**Pacific Gas and  
Electric Company**

PG&E Letter DCL-00-041

Docket No. 50-275, OL-DPR-80  
Docket No. 50-323, OL-DPR-82  
Diablo Canyon Units 1 and 2  
License Amendment Request 00-01,  
Administrative Revisions to the Improved Technical Specifications

## ADMINISTRATIVE REVISIONS TO THE IMPROVED TECHNICAL SPECIFICATIONS

Figure 2.1.1-1

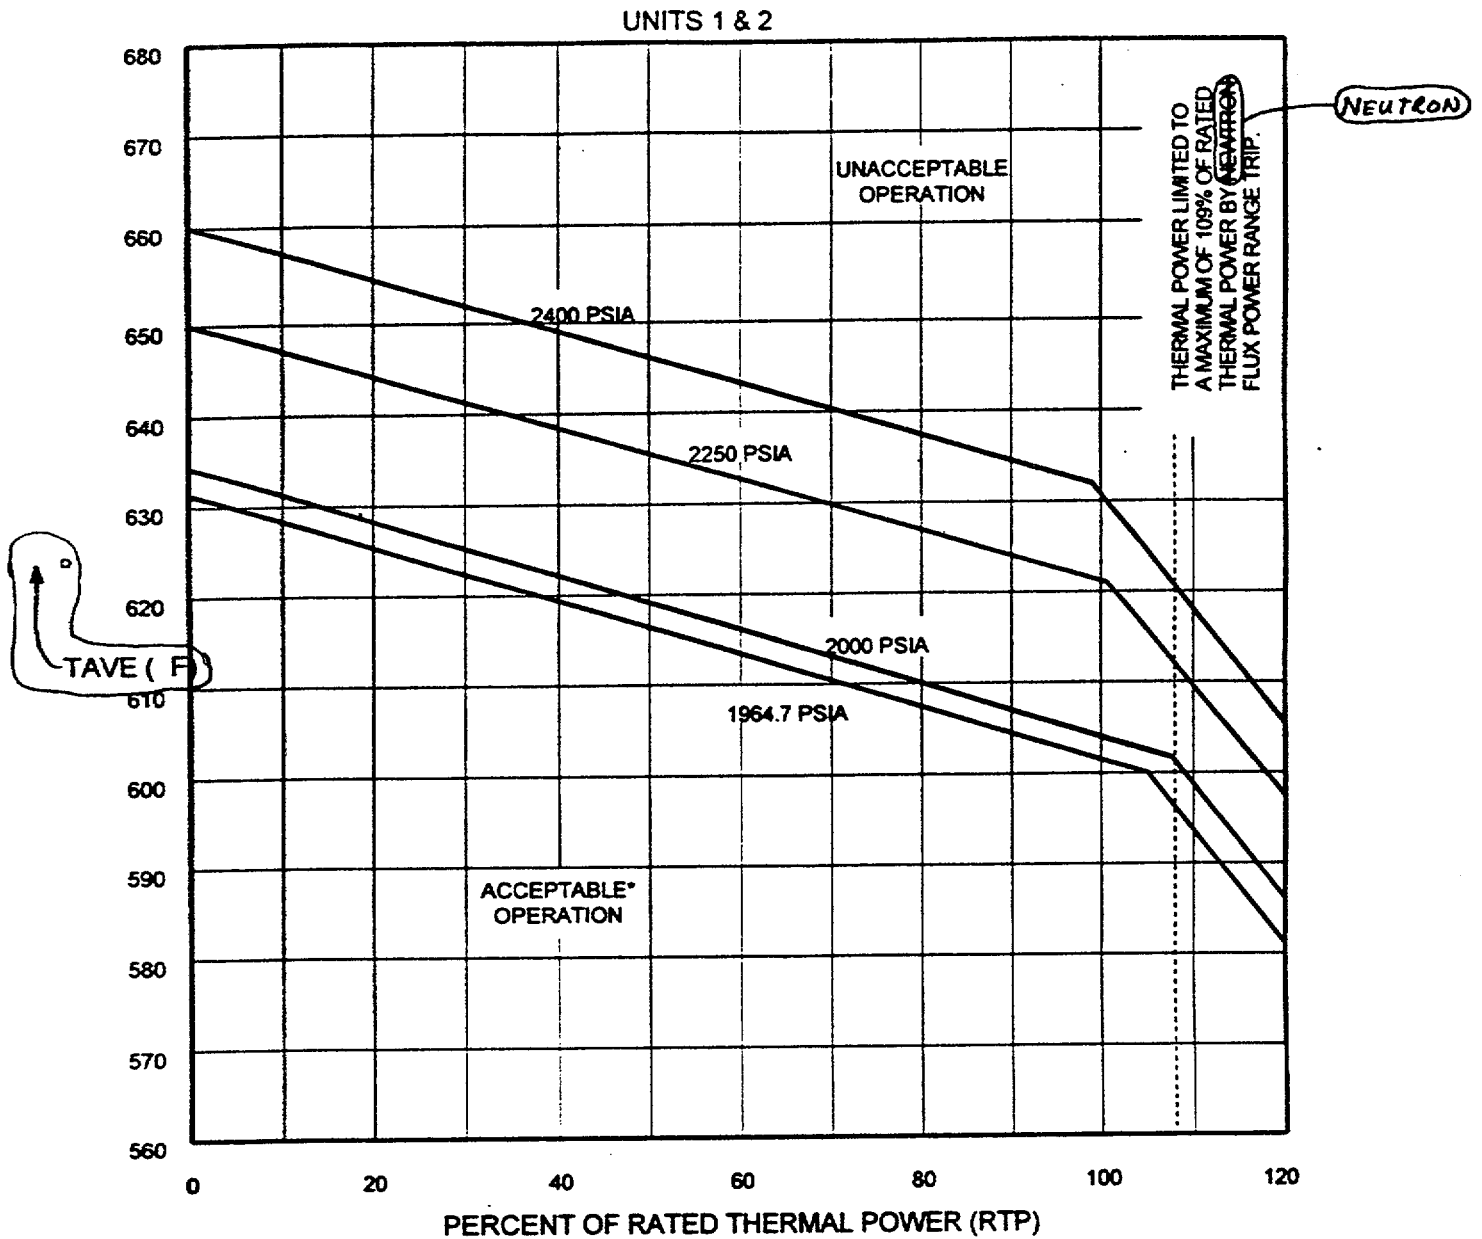
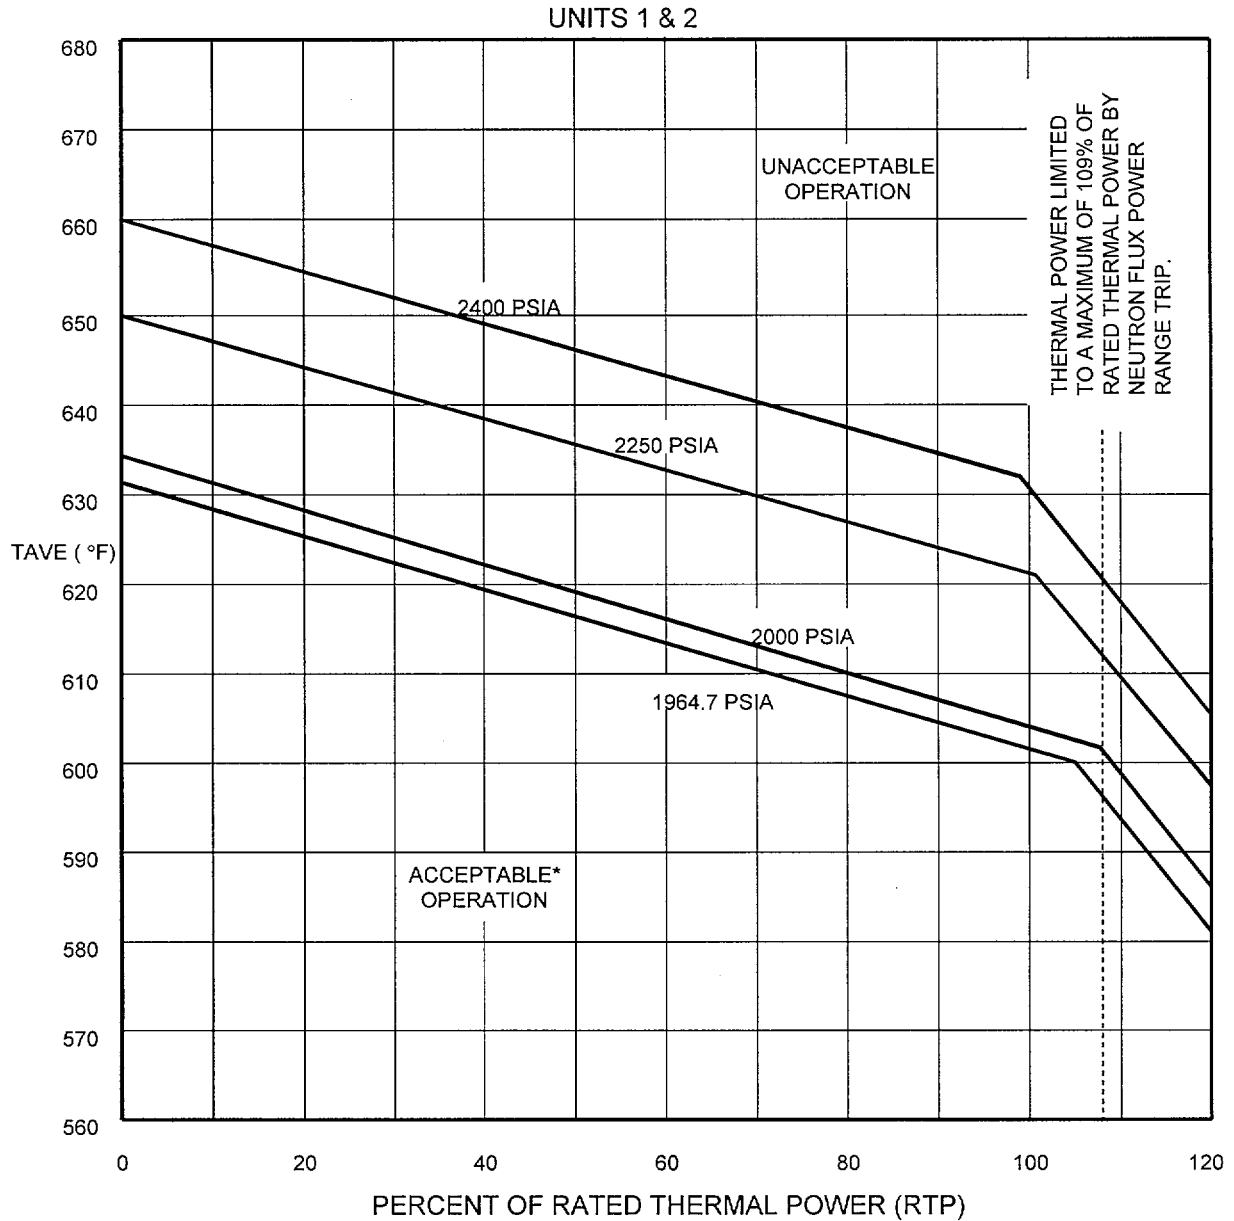
- a. Technical Specification (TS) 1.2, Example 1.2-2, Required Action A.2 - Correct the misalignment of the logical connector.
  - b. TS 2.1, Figure 2.1.1-1 - Correct spelling error and text misalignment.

Figure 3.1.3-1 (page 1 of 1)

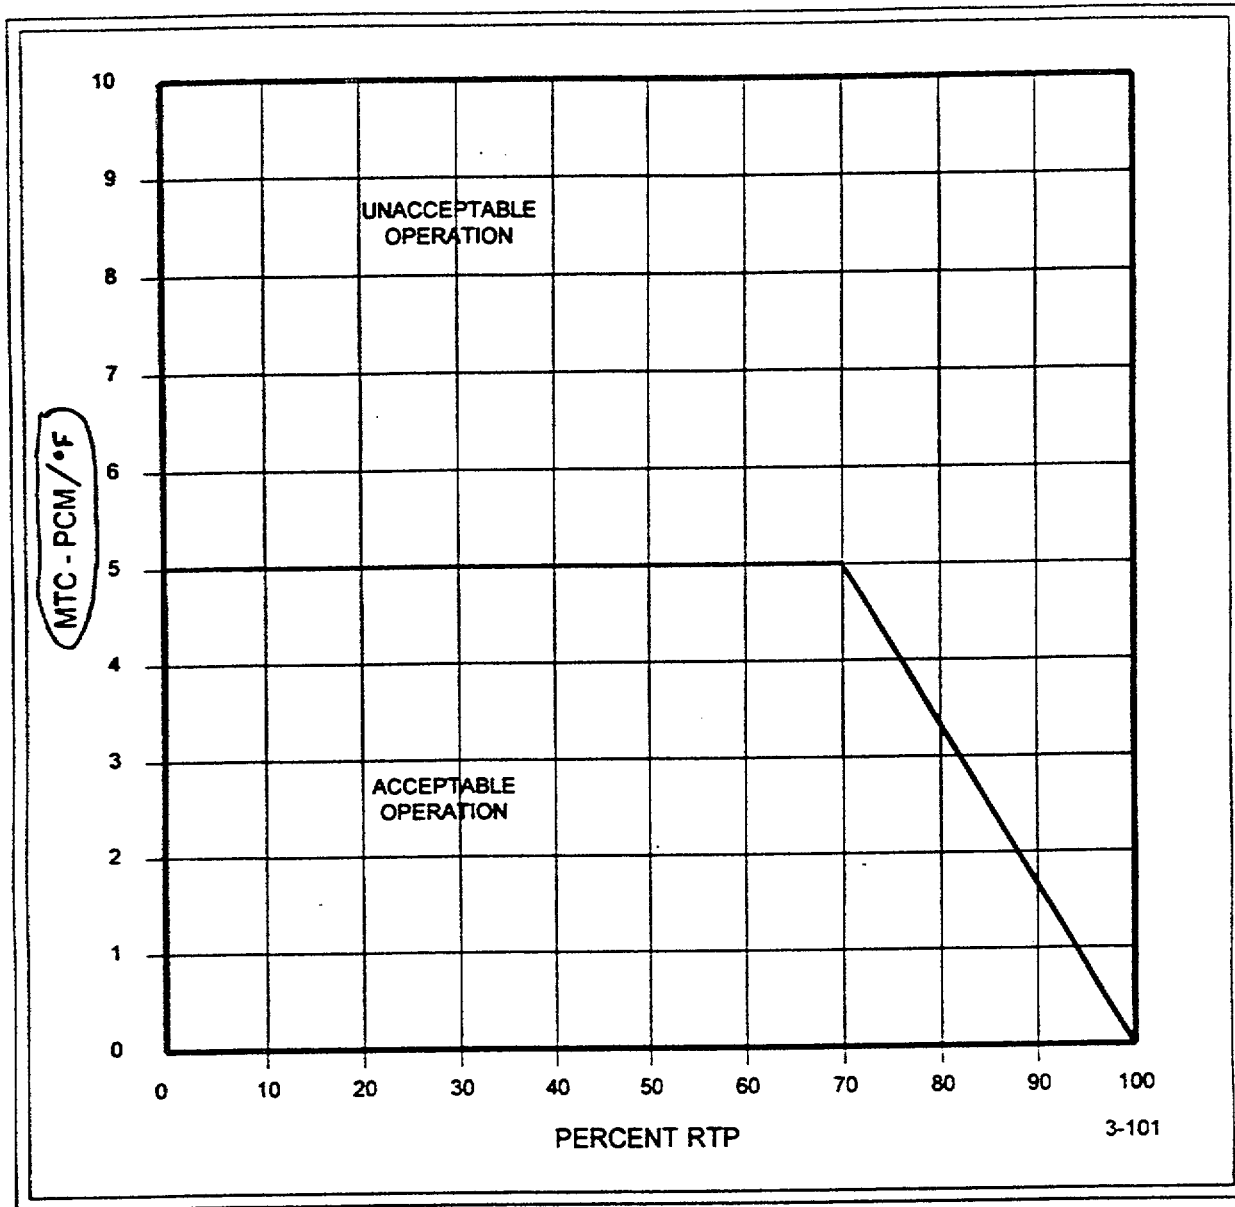
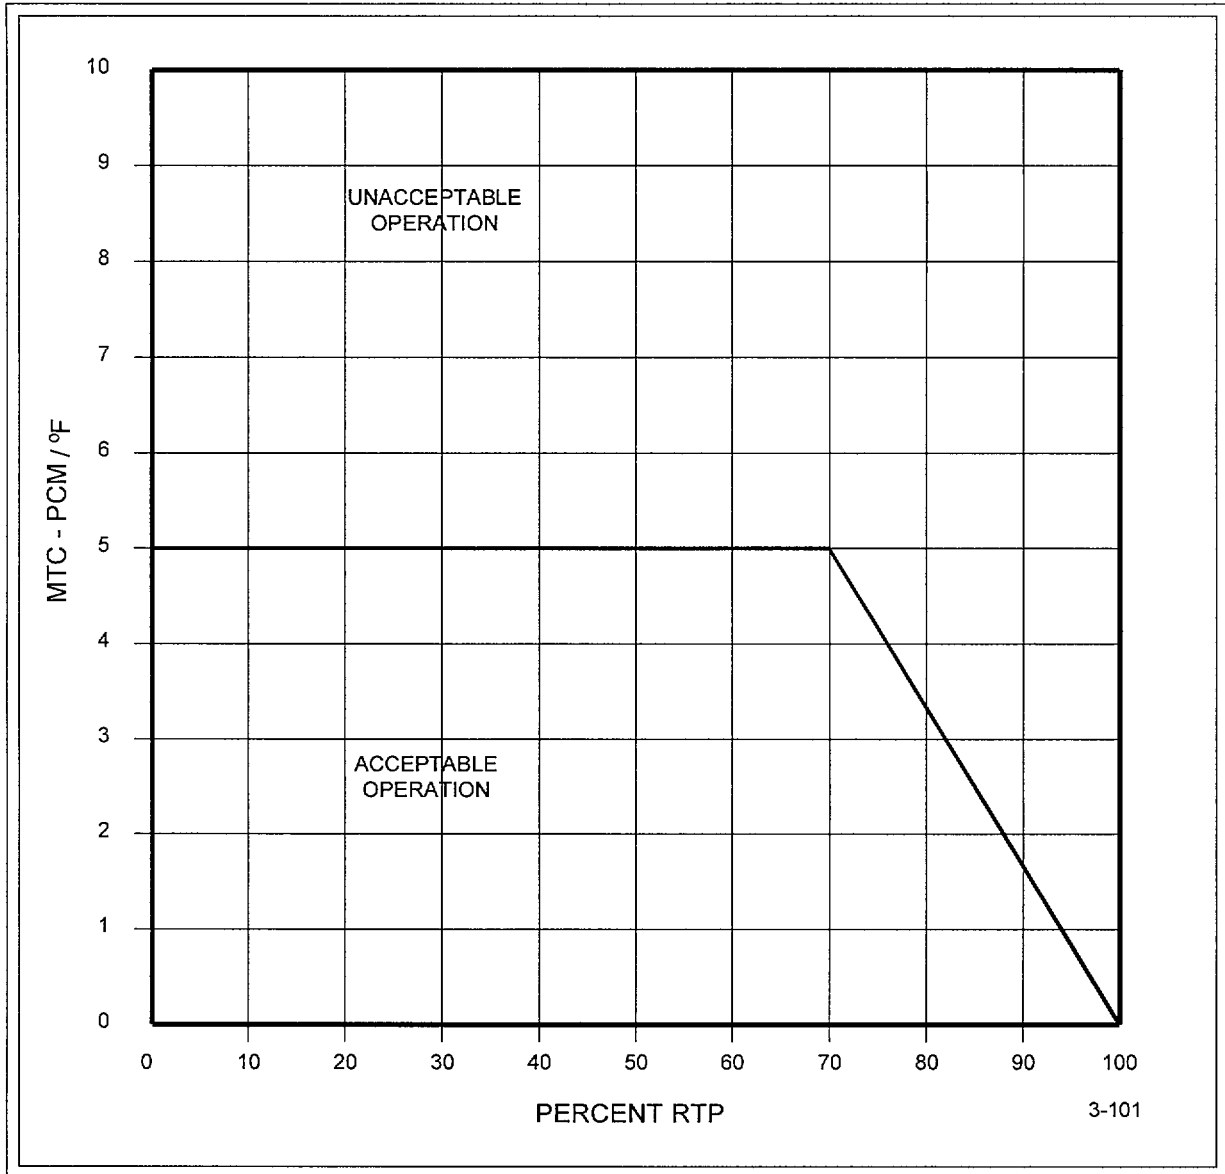
- c. TS 3.1.3, Figure 3.1.3-1 - Revise the legend to state MTC-PCM/°F rather than MTC-PCM.
  - d. Limiting Condition of Operation (LCO) 3.2.2, Required Action A 1.2.2. - Correct completion time misalignment.
